Subject: Permit Issuance Status and Compliance Inspection Summary

CAFO WPDES Compliance Report (September 12, 2012)

Inspection type: Permit Issuance Inspection

Operation Name: Kane Family Farm

Image 6: Image Direction: North

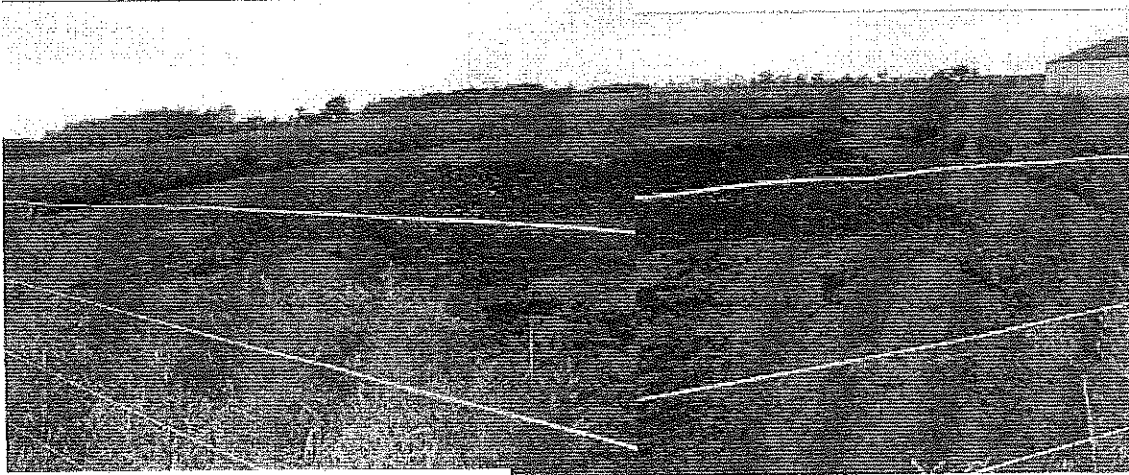
WSF #4 was operating with adequate freeboard. Manure storage level markers (including MOL) must be installed.

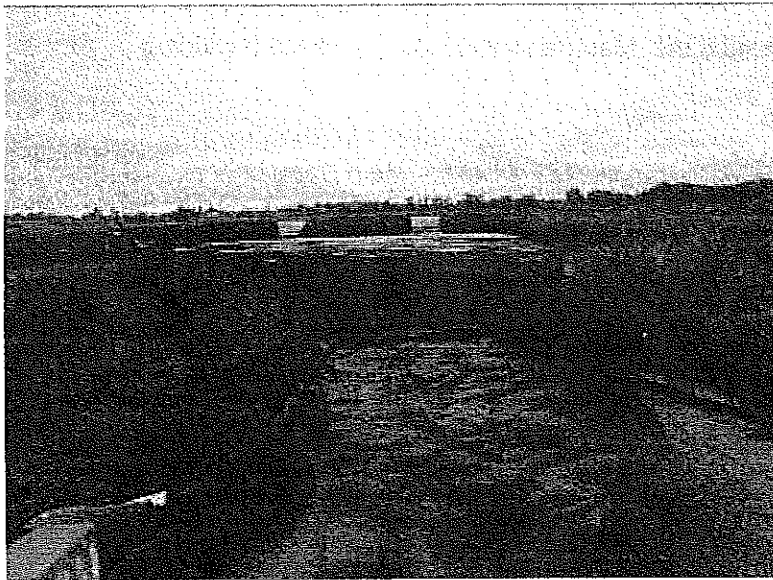
Image 5: Image Direction: South
WSF #3 is a clay lined basin with concrete agitation pads. The maximum operating level (MOL) marker was not observed during the inspection; the permit application states that the MOL is at elevation 103.3'. This marker must be installed in a location that is clearly visible.

Image 11: Image Direction:
East
Spilled milk travels through a
concrete channel to a filter strip
prior to entering a field.

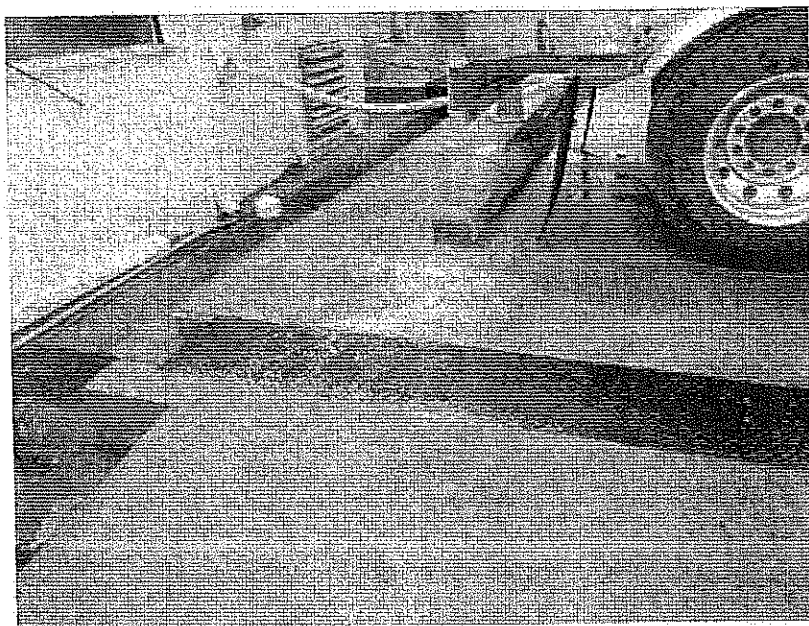
During the inspection spilled milk was noticed on the loading dock where the milk tankers were parked. This material enters a concrete collection channel and enters a small ditch before entering a filter strip that was designed by Brown County LCD to treat the contaminated runoff from the barnyard when it was in service. The material flows through the filter strip and continues west approximately to the west border of the temporary feed stack (Image 1). No evidence of further migration was witnessed; however, given the environmental impacts of milk house waste, it is important that measures are put in place to ensure that this issue is appropriately addressed and that the potential for an offsite discharge stops.
